CITY OF MILWAUKIE

DESIGN AND LANDMARKS COMMITTEE

- 6.1 Summary: Updates to Downtown Design Review code (revisited)
Staff Person(s): Brett Kelter, Senior Planner; Elizabeth Decker, JET Planning
 - Discuss questions raised in discussion guide
 - Graphics update

REVISED DRAFT

Figures:

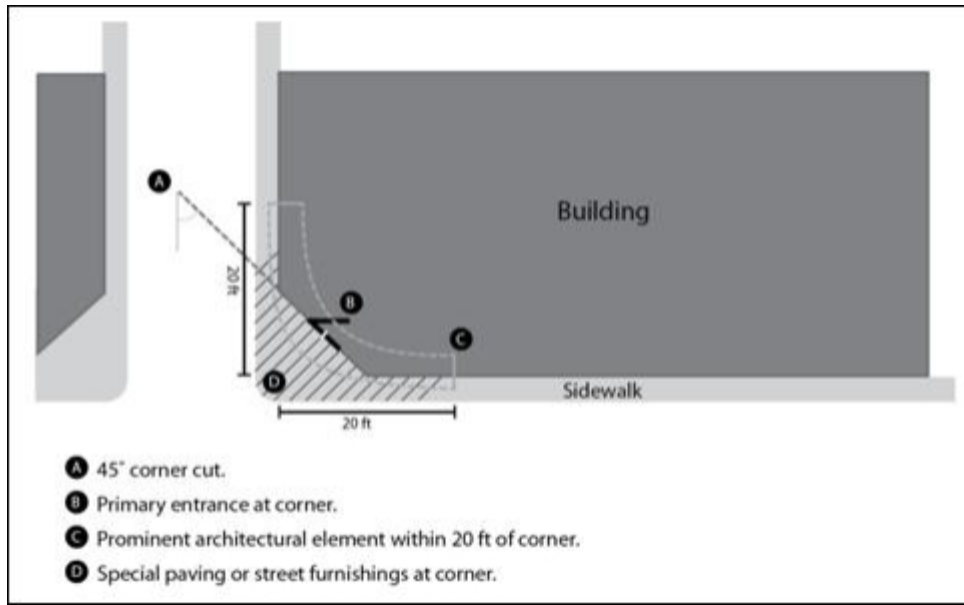
Make the image larger and clearer—zoom in on the corner of the graphic to show more detail.

For purposes of the illustration, the door should swing out.
